Our Ref: QCG-10389

Subject: 10 CFR 21 Notification, Cooper-Bessemer  
KSV Emergency Diesel Generator Power Piston Failure

KSV Power Piston Potential Deficiency:

ATTACHMENT TO QCG-10389

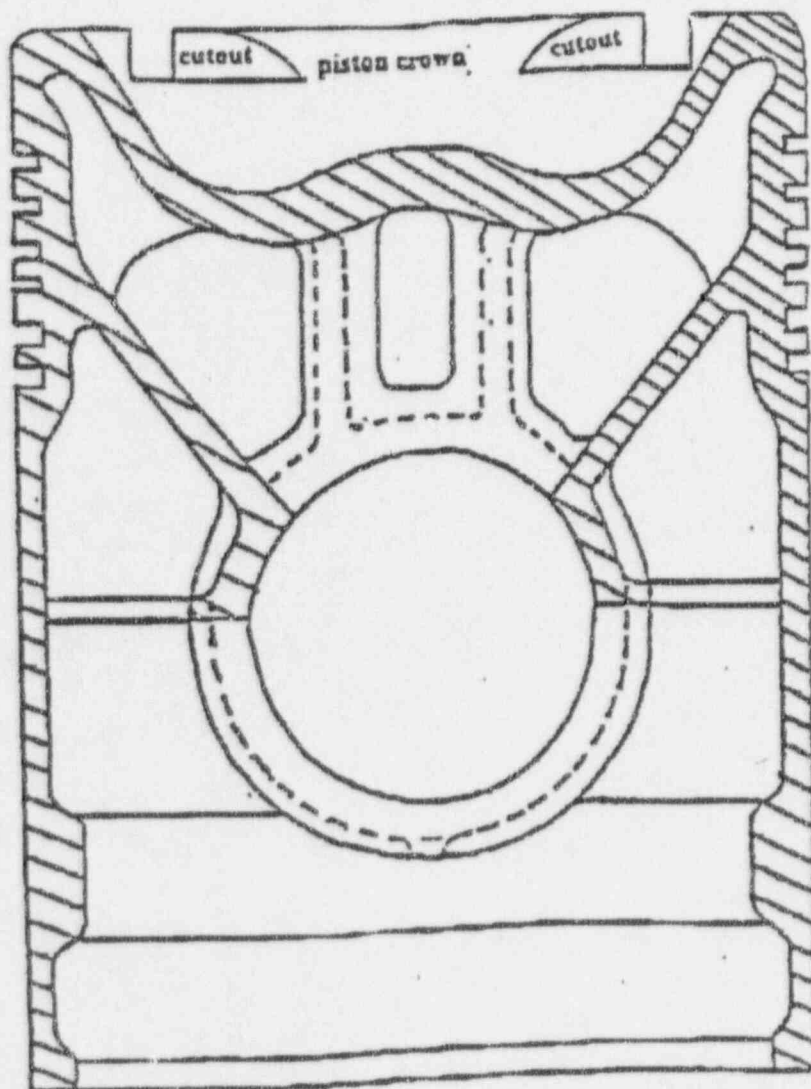
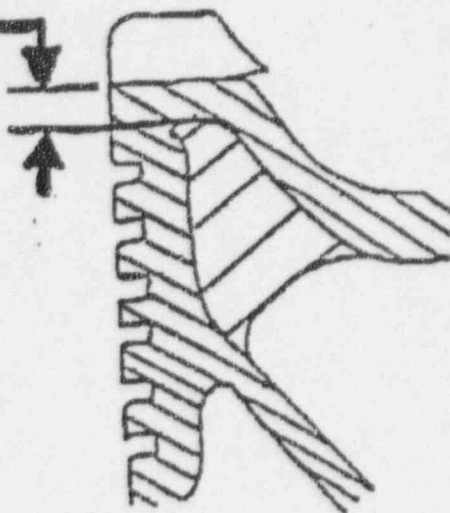
The potential defect concerns the thickness of the piston crown in the valve cutout area (see attachment) that provides clearance for the intake and exhaust valves. The nominal design thickness for this area is .438. The failed piston at CECo had an area that tapered down to a minimum thickness of .040.

Finite Element Analysis performed by CES subsequent to the failure has indicated an acceptable minimum thickness in the valve cutout area of .100. The analysis also indicated that a .040 thick piston should not fail in normal operation, but the factor of safety is below normally accepted values. Examination of pistons in CES stores noted many in the .25-.31 range and one as low as .070.

The root cause of the deficient condition was an incorrect foundry pattern.

Using Ultrasonic or similar measuring equipment, the crown thickness at the valve cutout should be verified to be .100 minimum. For pistons currently installed in engines this can be done during normal maintenance activities when the pistons become accessible. Immediate verification is not considered necessary based on the following:

- Revision of the foundry pattern to correct crown thickness.

- Inclusion of specific verification of crown thickness in the valve cutout area during the production process.
- Inclusion of specific verification of crown thickness in the valve cutout area during the refurbishment process of used pistons.
